This letter is to inform you that our 2K bezel for cap series 1KS/1KBS/1KCS (and 1K/1KB/1KC) has been upgraded.

Picture 1 – Close Up

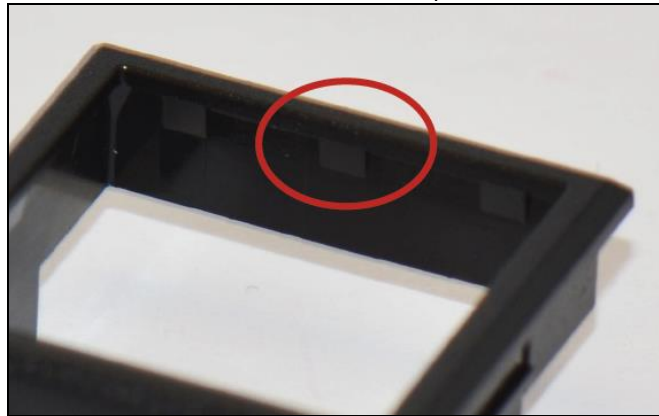
The “slopes” on the inside of the bezel have been widened and a third “slope” was added on all four sides, so now there are three “slopes” on all inner sides of each bezel. These “slopes” eliminate the chance of a cap getting stuck under the recess when pressing it unevenly.
